SUBJECT: Transmittal of Revised Responses to AP1000 DSER Open Items

AP1000 Design Certification Review  
Draft Safety Evaluation Report Open Item Non-Proprietary Responses

**DSER Open Item Number:** 3.8.2.1-1 Revision 2

**DSER Open Item Number:** 19.1.10.1-5 (Response Revision 2)

Figure A3.5-1

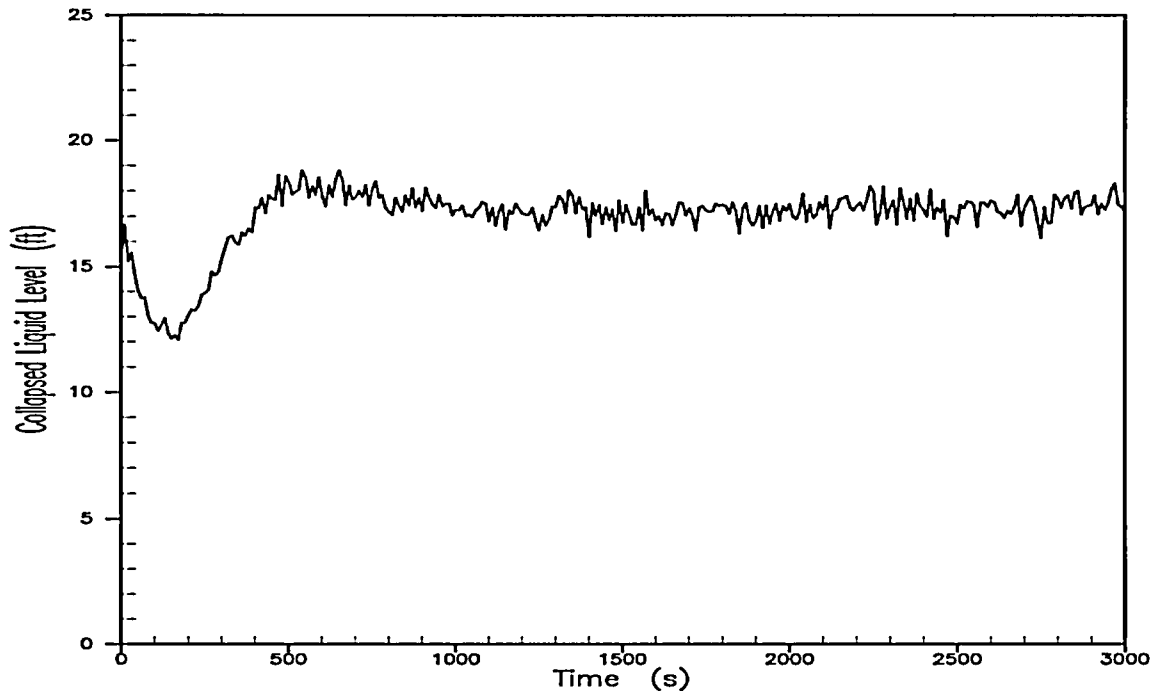
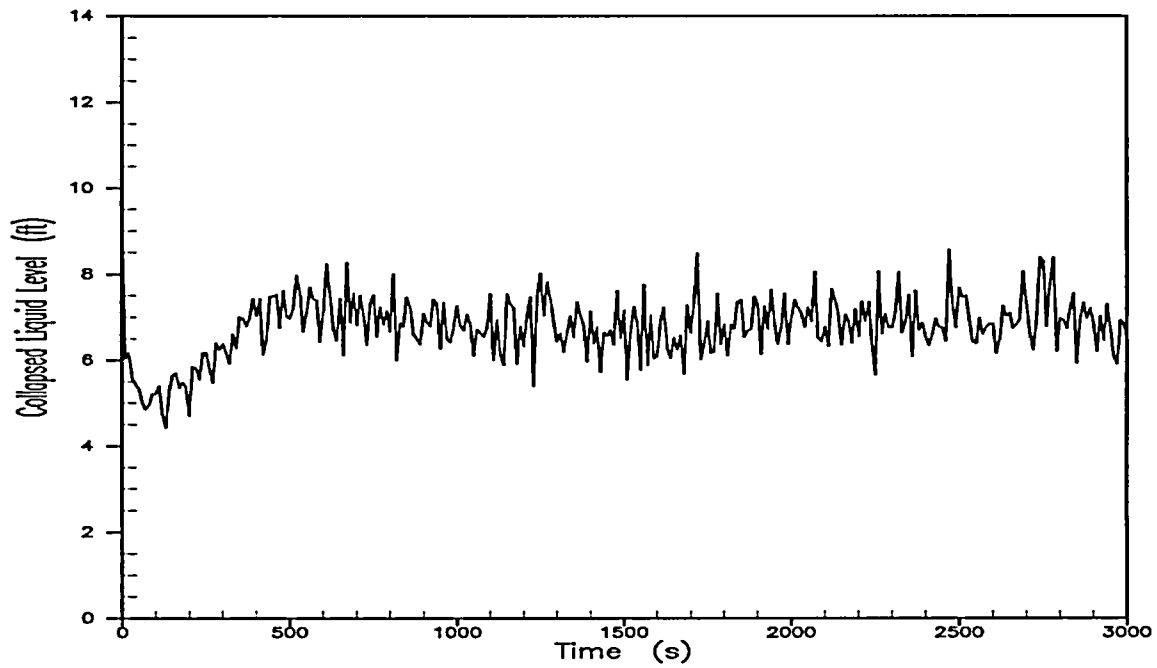
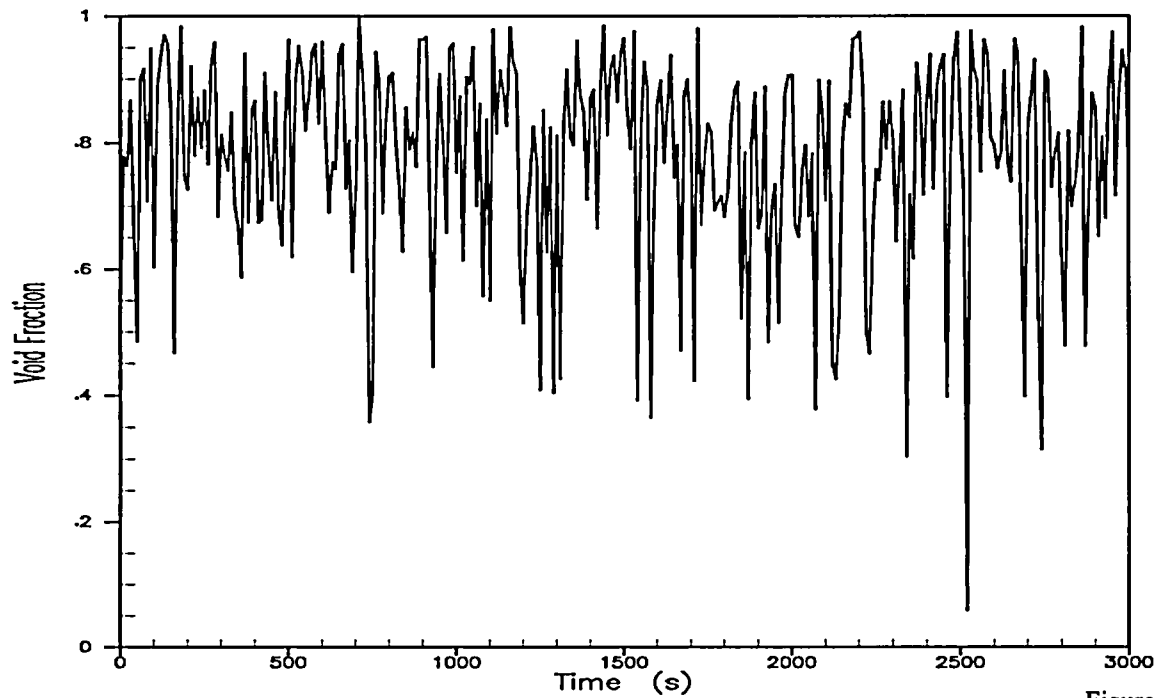
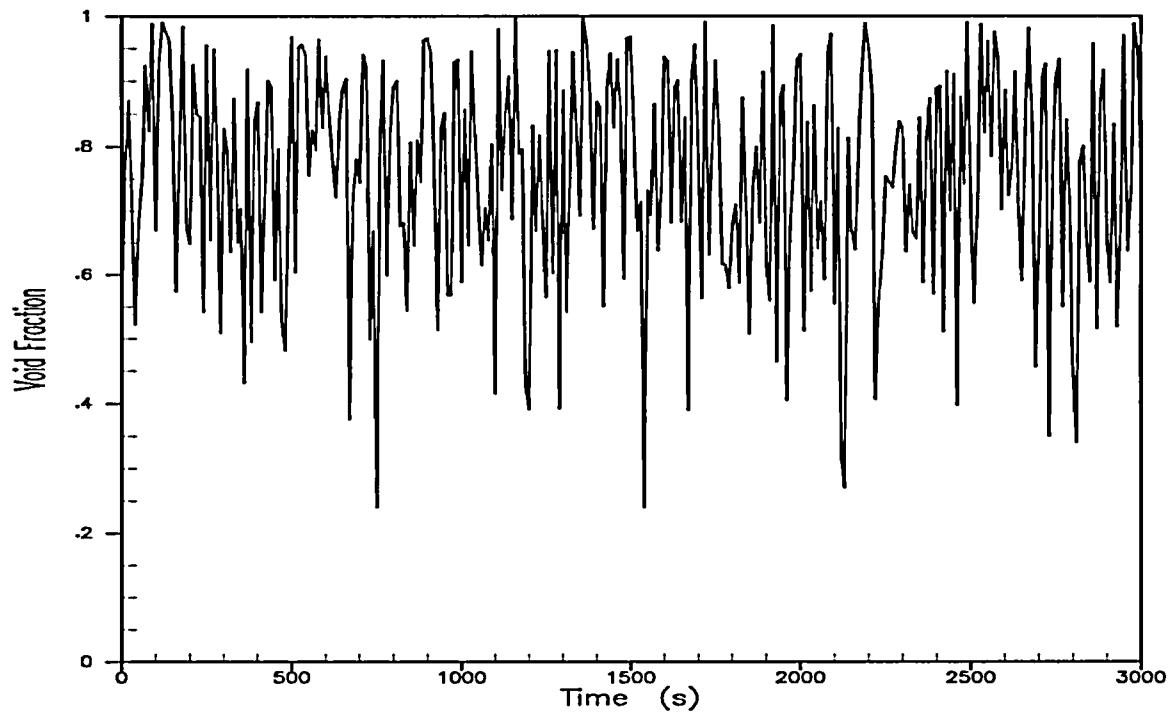
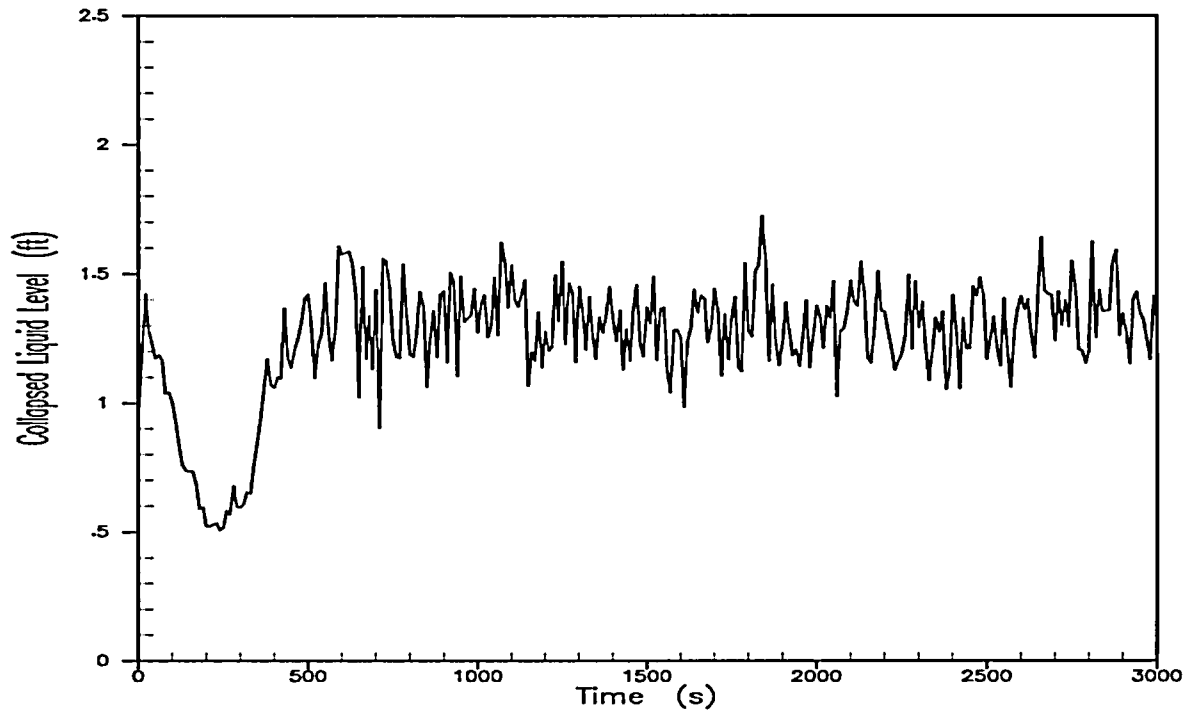
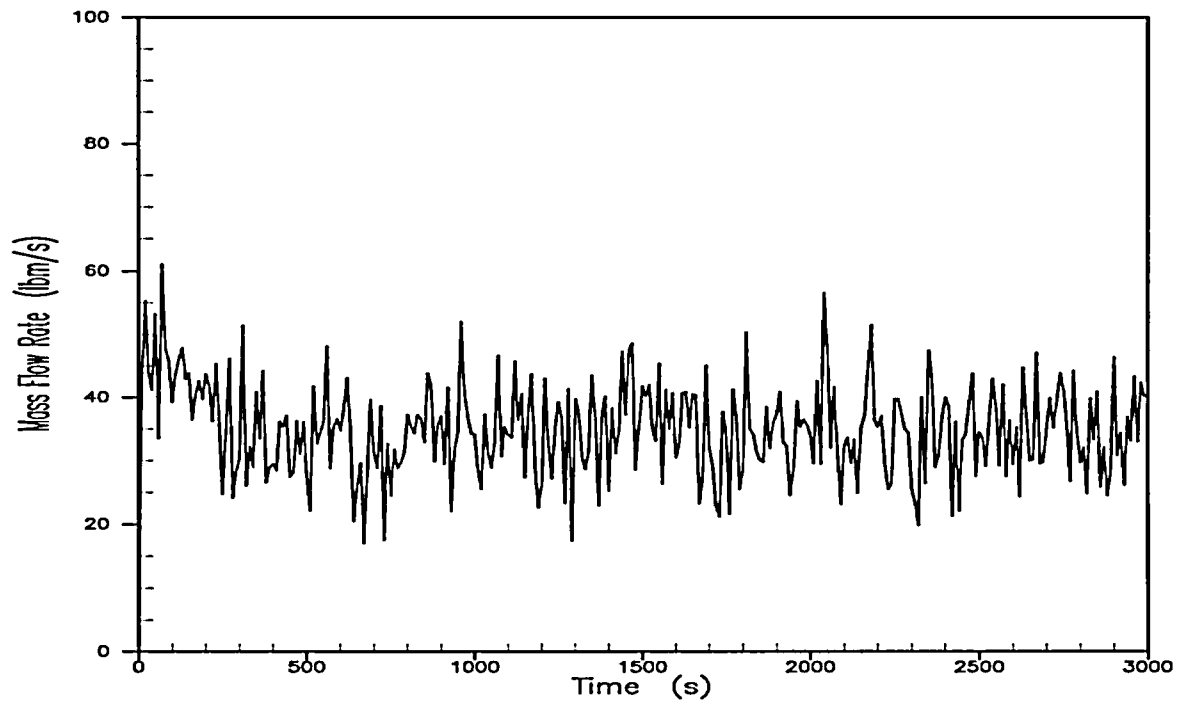
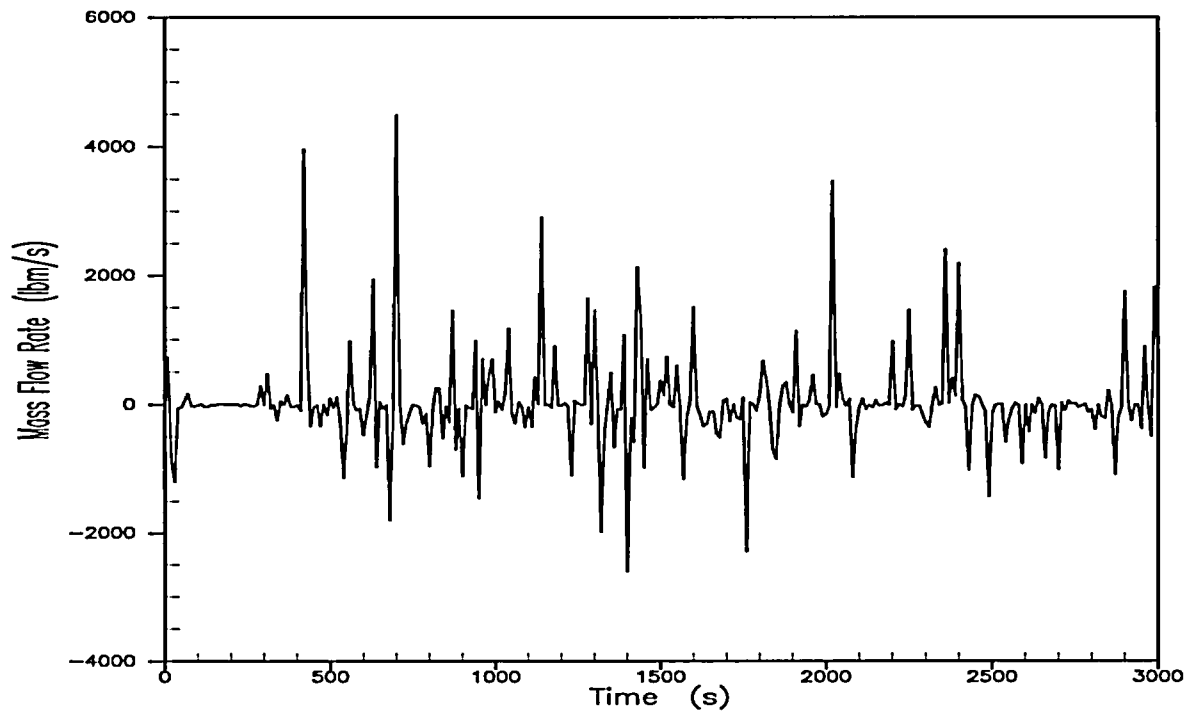
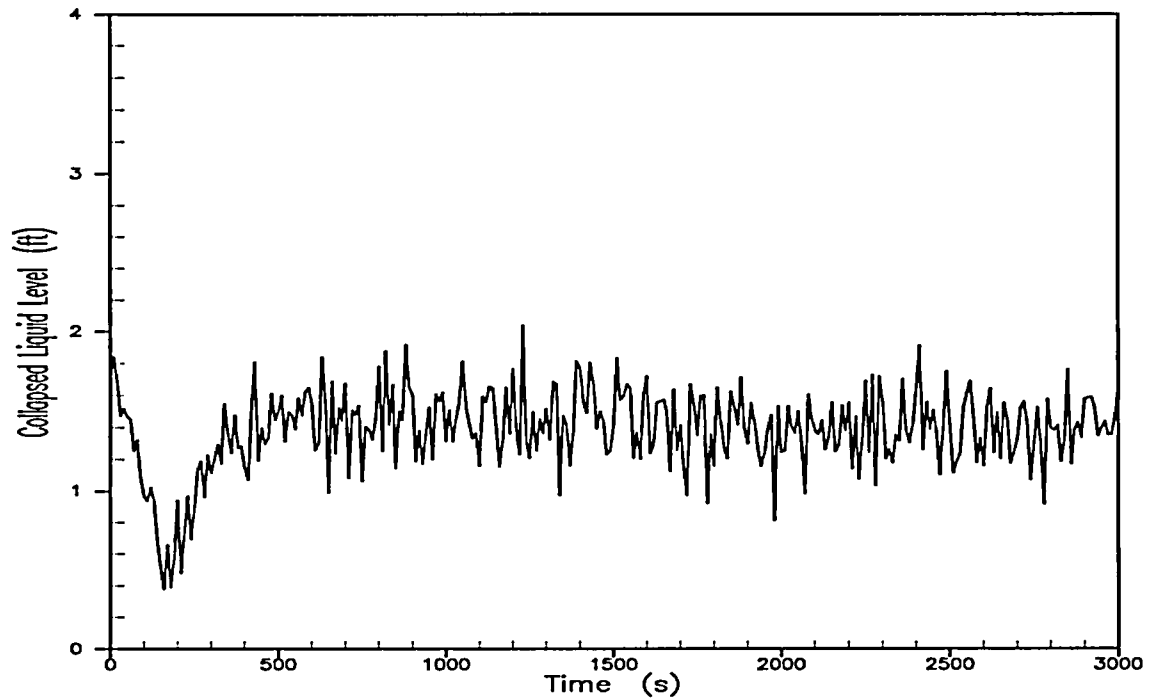
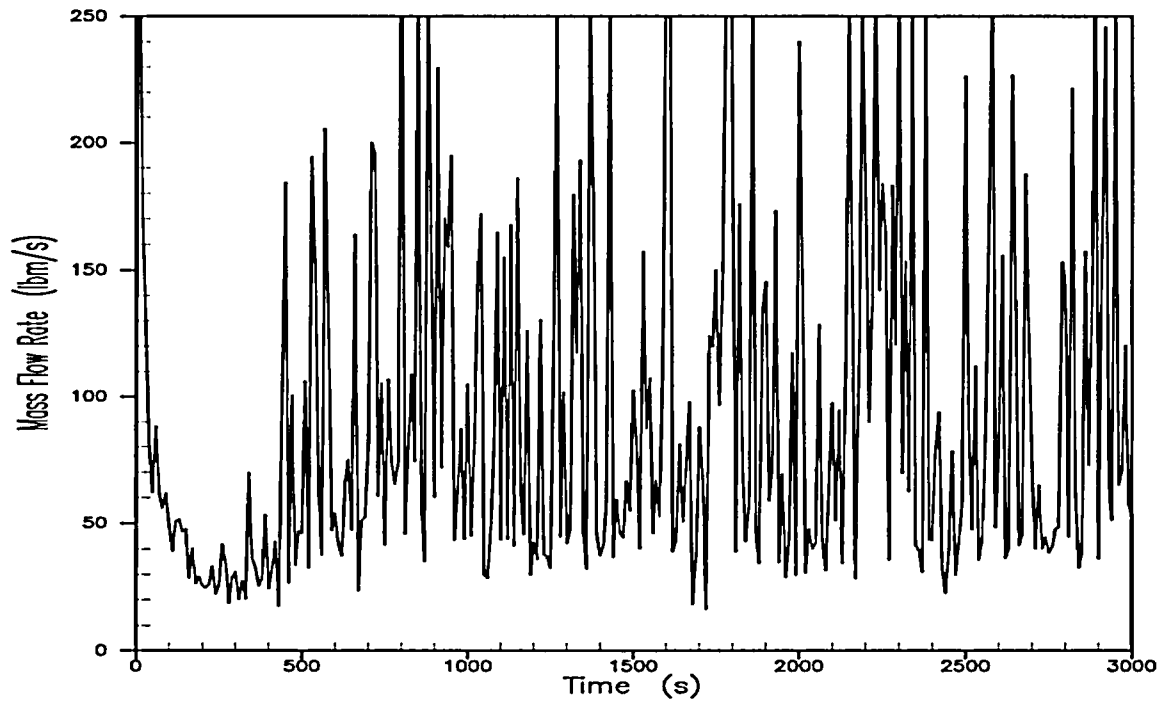
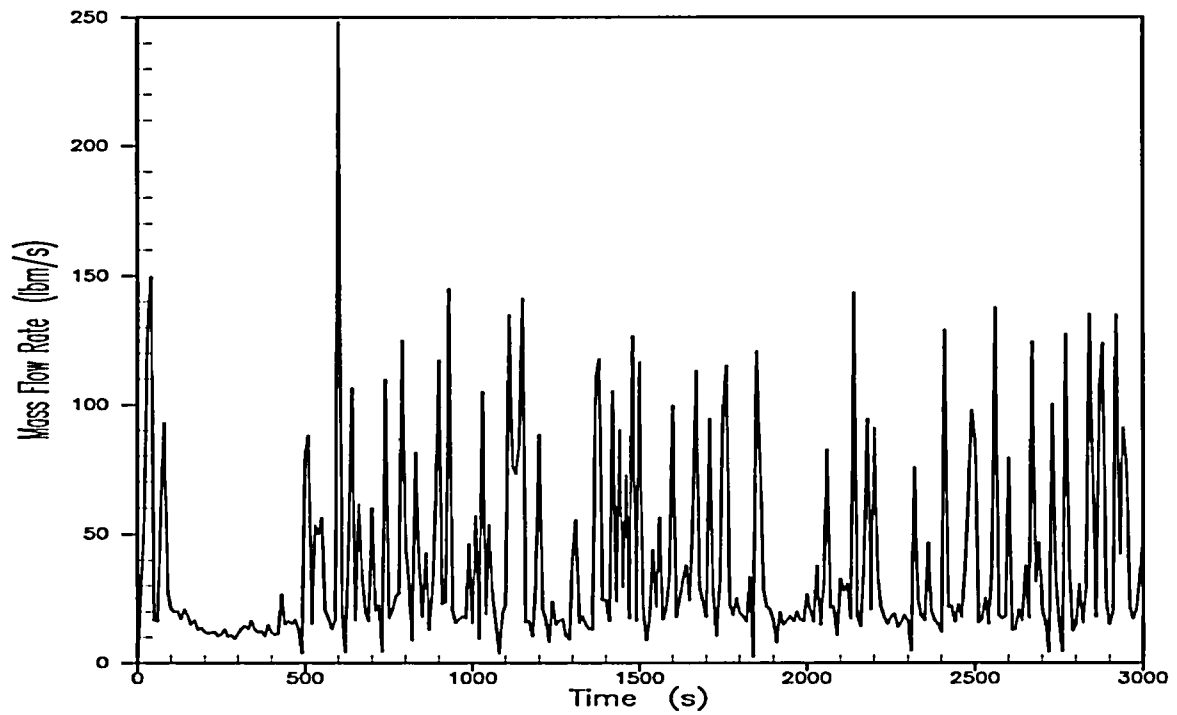
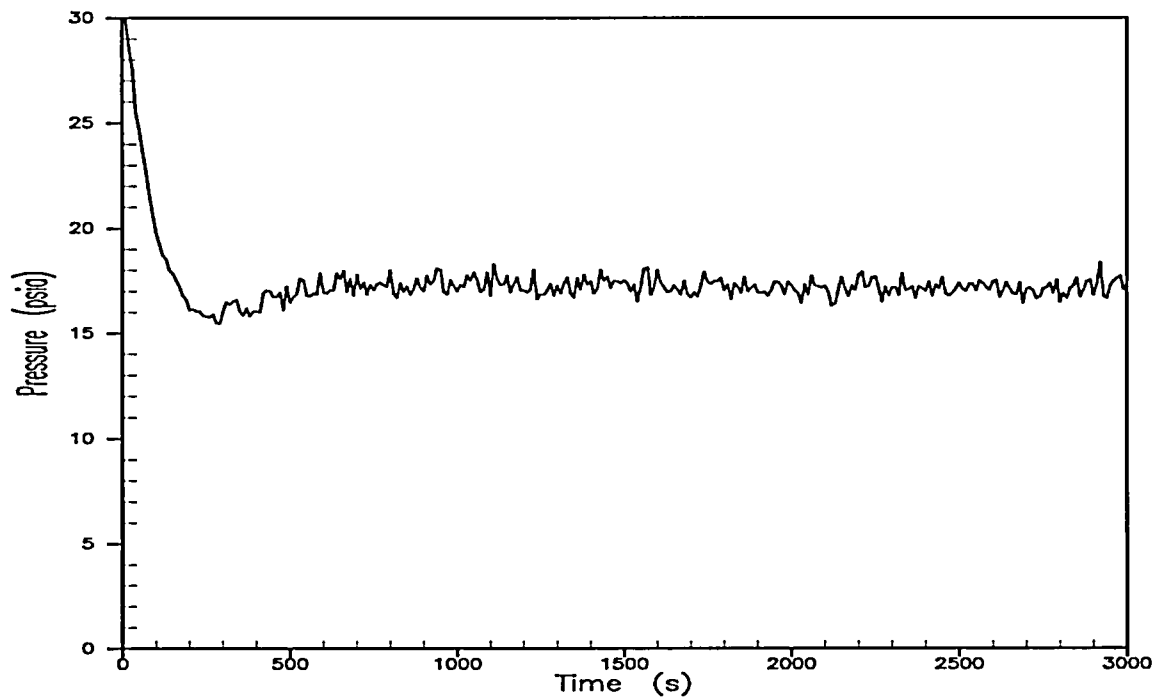
This issue remains open. In the revised response to RAI 720.013, Westinghouse performed long term cooling analyses for bounding conditions in the PRA. (Case F DEDVI, 1 CMT, 1 recirc line, 3/4 ADS4 and CI) and (Case G DEDVI, 1 CMT, 1 recirc line, 4/4 ADS4 and CI failure). The WCOBRA/TRAC code was used for LTC calculations with input conditions derived from MAAP4 analyses. As discussed in the DSER the staff has not reviewed MAAP4 except for its use in screening studies. These are analyses using minimum equipment sets as discussed in the DSER. The staff believes that only a methodology the staff has reviewed should be utilized. In addition, as a result of staff and ACRS questions, the WCOBRA/TRAC long term cooling model has been changed. The staff believes that the revised model should be used in these bounding calculations.

- (a) The long term cooling success criteria analysis case and the thermal hydraulic uncertainty cases F and G have now been performed using the revised WCOBRA/TRAC model and using input conditions from WGOthic. The revised cases replace the previous cases as shown below in the revision to PRA Appendix A.

into the downcomer through the DVI break supplements the IRWST injection. As this flow path becomes established, the levels in the downcomer (Figure A3.5-1), the reactor core (Figure A3.5-2), and the upper plenum (Figure A3.5-8) are sufficient to maintain core cooling. The effect of this injection flow increase is also seen in Figures A3.5-3 and A3.5-4, which show a void fraction decrease in the upper half of the core.

The three available ADS Stage 4 valves provide enough venting capacity that adequate depressurization capability exists to achieve successful performance of the passive safety systems (Figures A3.5-9 and A3.5-10). The fuel remains covered throughout the transient, and adequate core cooling is provided to remove the decay heat. The hot rod cladding temperature at the top of the core is slightly above saturation temperature (Figure A3.5-12) throughout the transient.
